UNITED STATES
NUCLEAR REGULATORY COMMISSION
WASHINGTON, D. C. 20555

The Commission has issued the enclosed Amendments Nos. 93, 93, and 90 for Licenses Nos. DPR-38, DPR-47 and DPR-55 for the Oconee Nuclear Station, Units Nos. 1, 2 and 3. These amendments consist of changes to the Station's common Technical Specifications (TSs) in response to your request dated August 25, 1980, as supplemented December 22, 1980 and January 22, 1981.

These amendments revise the TSs to support the operation of Oconee Unit No. 3 at full rated power during Cycle 6. The amendments also add a new TS 3.1.11, Shutdown Margin, and a new Section 3.5.2.9 to TS 3.5.2, Control Rod Group and Power Distribution Limits, for Oconee Units Nos. 1, 2 and 3.

SAFETY EVALUATION BY THE OFFICE OF NUCLEAR REACTOR REGULATION

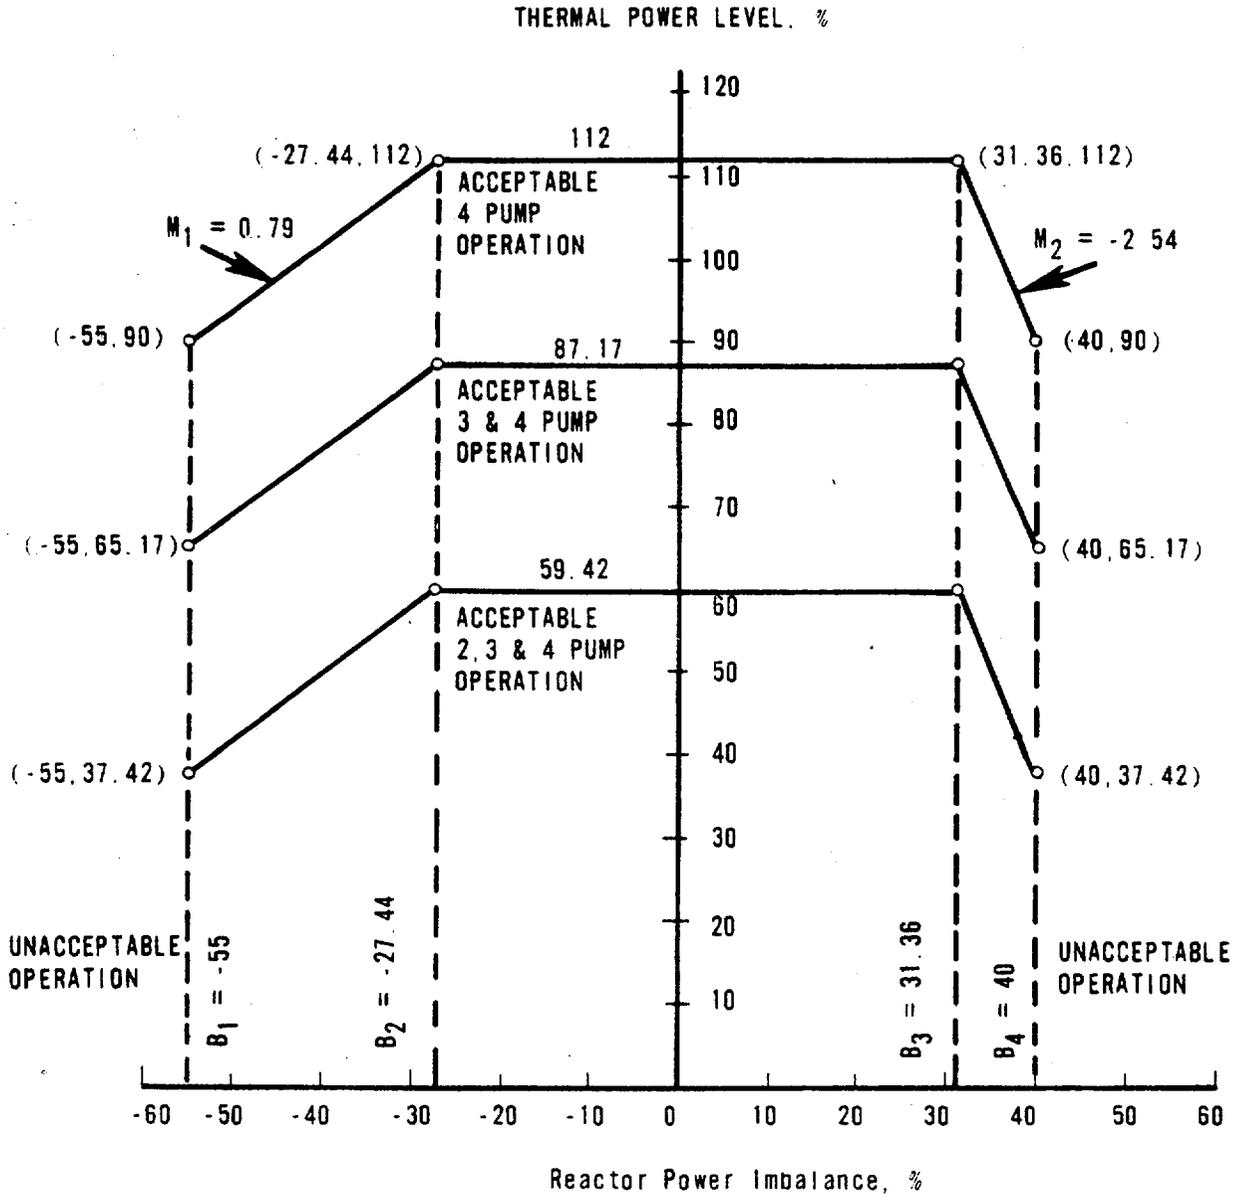
The proposed modifications to the Core Protection Safety Limits of Specification 2.1 (Figure 2.1-3C, Page 2.1-12 of Ref. 1) have been reviewed for the Oconee 3 Cycle 6 operation, and we find the revised TSs acceptable. The TS changes related to cycle length and shutdown margin have been reviewed in Sections 2.7 and 2.8 of this Safety Evaluation.

Figure 2.1-2C

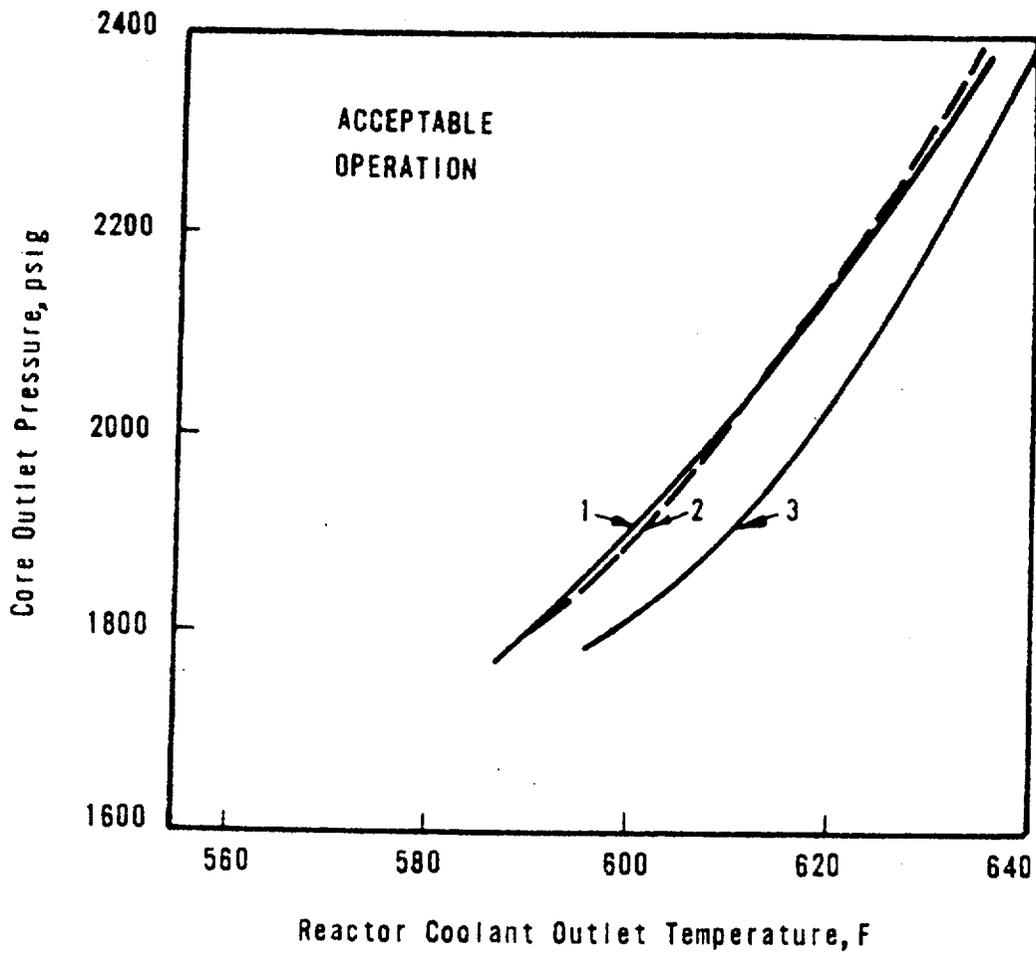
The specified flow rates for Curves 1, 2 and 3 of Figure 2.1-2C correspond to the expected minimum flow rates with four pumps, three pumps and one pump in each loop, respectively.

ROD POSITION LIMITS
 FOR FOUR-PUMP OPERATION
 AFTER 200 (+ 10) EFPD
 UNIT 3
 OCONEE NUCLEAR STATION
 Figure 3.5.2-1C3

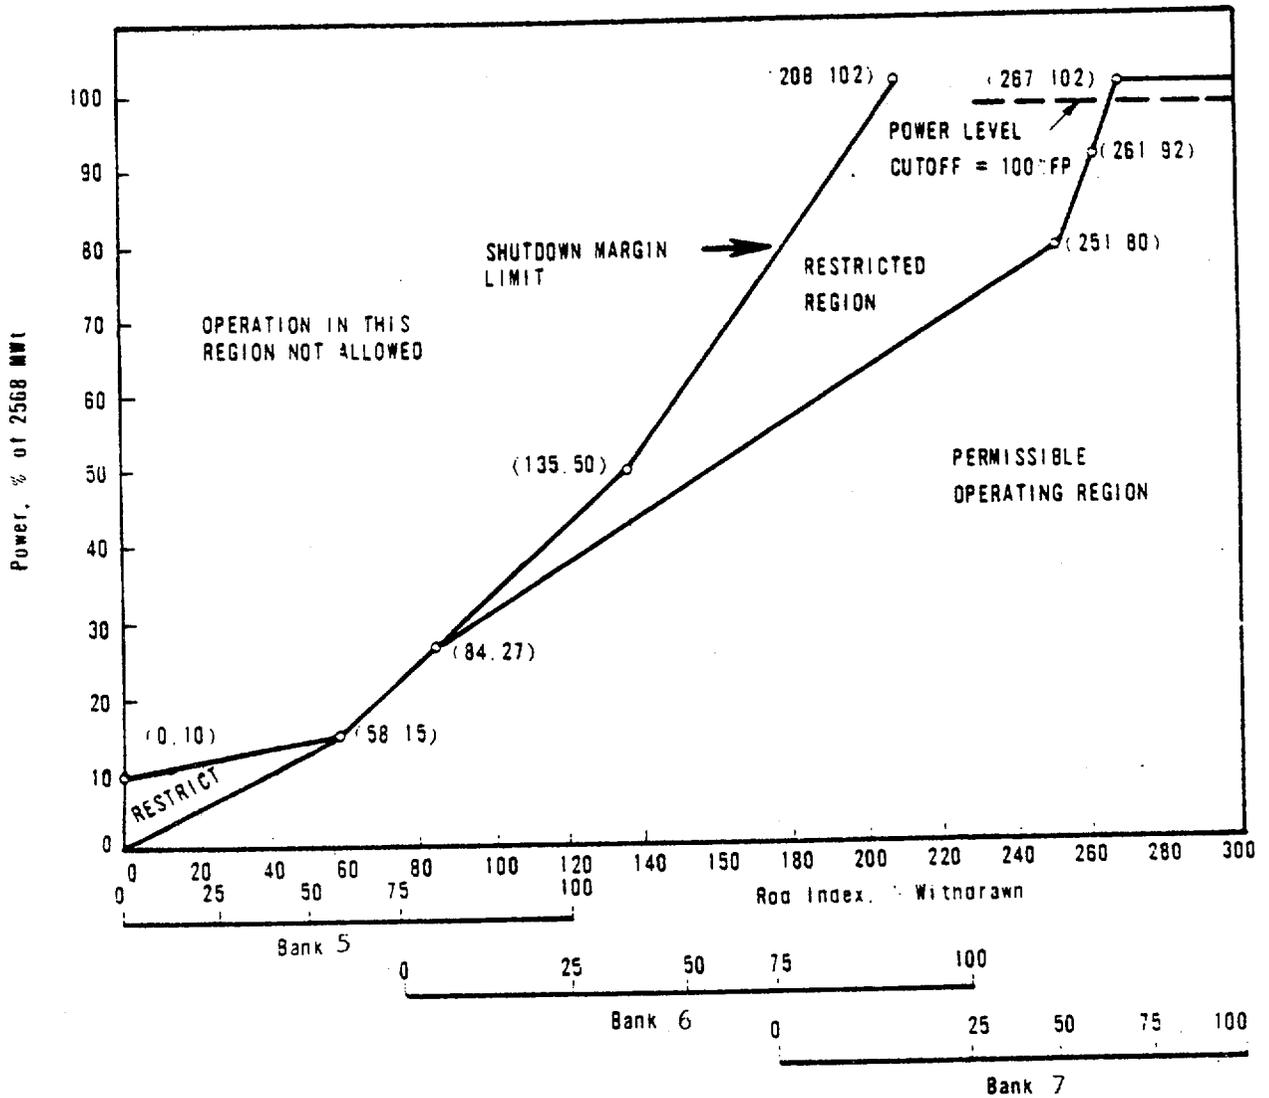
A further TS (3.5.2.9) specifies that the curves shown in the various Specifications shall be valid only to the end of the nominal cycle length (in spite of the open ended nature, e.g., Figure 3.5.2-1C3 which is designated for use after 200 ± 10 EFPD).

However, use of these curves would be permitted after the end of the nominal cycle if analyses are performed which confirm their suitability. Such use would not, therefore, involve a TS change. If analyses failed to confirm the suitability of the curves, a TS change would have to be obtained to continue operation beyond the nominal cycle length. We find this approach to be acceptable.
